SUSQUEHANNA STEAM ELECTRIC STATION
COMMENTS ON SUPPLEMENT 2 OF
DRAFT ENVIRONMENTAL STATEMENT
ER 100450 FILE 991-2 PLA-818

Applicants have reviewed Supplement No. 2 to the Draft Environmental Statement related to the operation of the Susquehanna Steam Electric Station Units 1 and 2 (NUREG-0564) and in general concur with the Staff's analyses, evaluations, and conclusions. Applicants believe the Supplement meets the intent of the Commission's statement of interim policy regarding accident considerations and agree with the Staff's conclusion that while the environmental impacts of the accidents considered may be severe, the likelihood of their occurrence is remote. Therefore, the conclusions reached in the Draft Environmental Statement should remain unchanged.

Fig. A.4.1. Inlet-Outlet Structure:

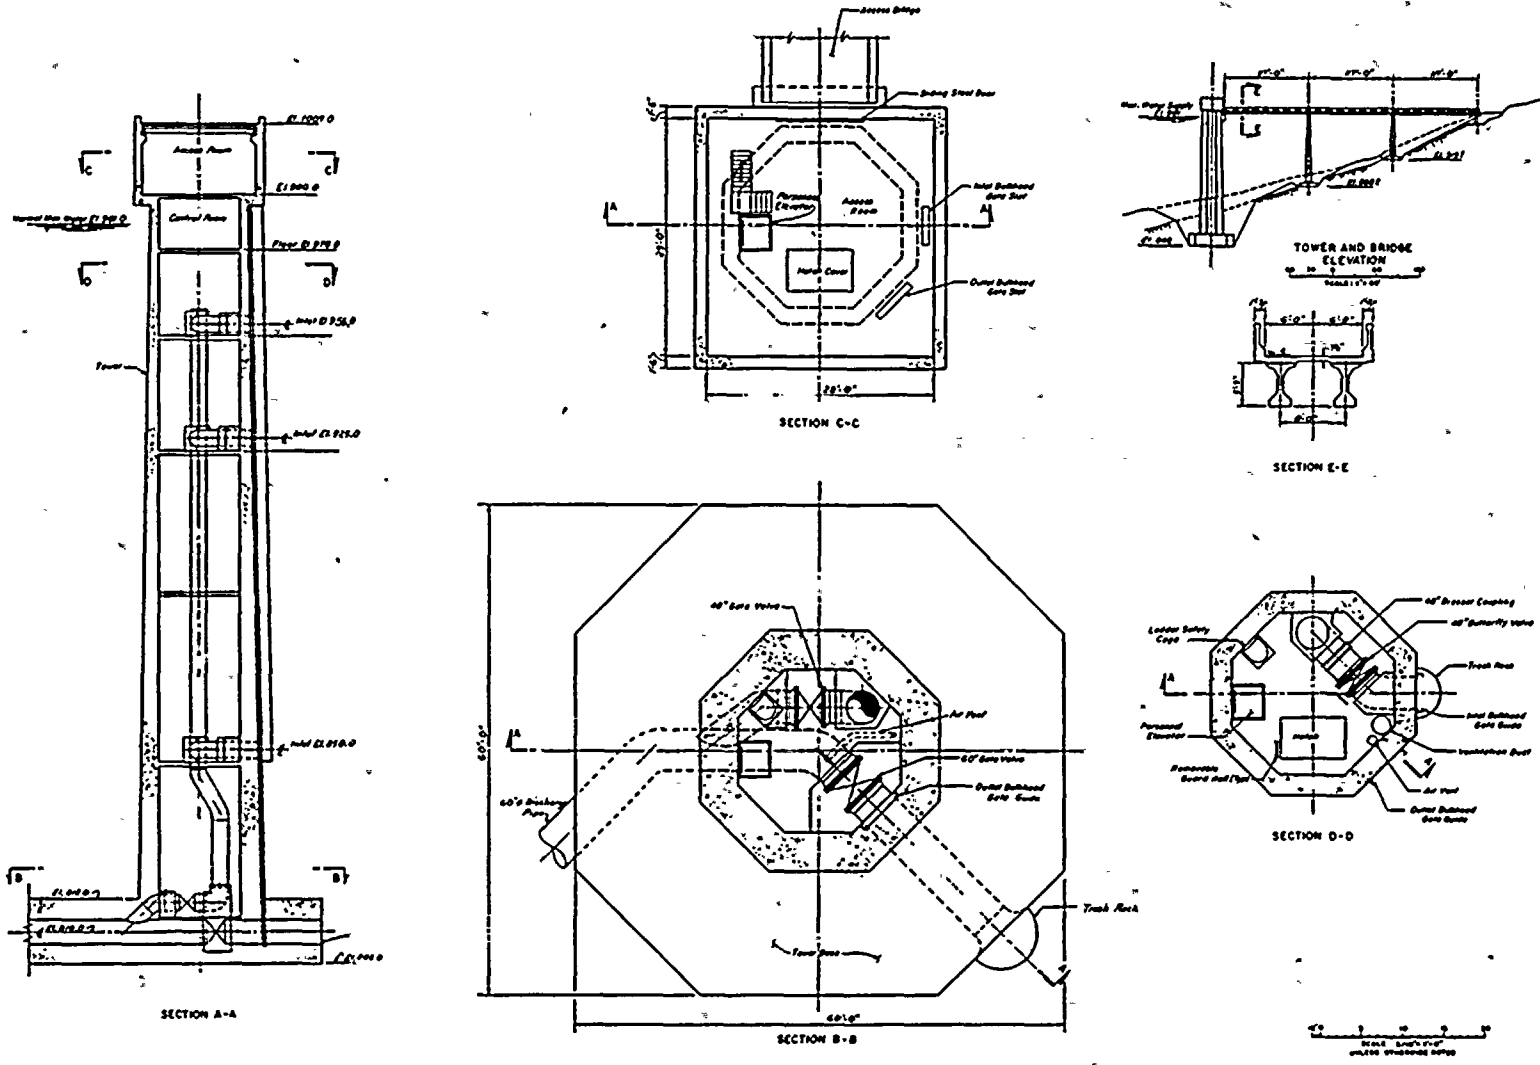
The applicant indicates that the quality and temperature of water discharged from the reservoir into the downstream section of Pond Hill Creek and the Susquehanna River will be controlled by the multilevel inlet-outlet structure (ER-OL, Sec. 4.3.1). The outlet ports for compensation releases in the revised inlet-outlet structure (Fig. A.4.1) will be at the 291.4, 282.0, and 259.1 m levels. The applicant has performed new thermal modeling analyses for the reservoir, using the schedule of compensation releases that would be required for 1964 drought conditions and the two sets of meteorological data, 1964 and 1975 (PP&L Comment letter, 29 May 1980; Letter 17 of Appendix B). The results of these calculations are given in the above comment letter.

The text and Figure A.4.1 have been revised to reflect applicable comments.

This structure has been redesigned since the DES was issued in March 1980 (letter from M.N.W. Curtis, PP&L to Mr. B.J. Youngblood, NRC, 29 May 1980; this letter is on page B-47 of Appendix B). The new structure is shown schematically in Figure A.4.1; its location is given in Figure A.2.3). The new design calls for a vertical structure inside the reservoir, with exit ports 7.6, 17.0 and 39.9 m below the normal water surface.
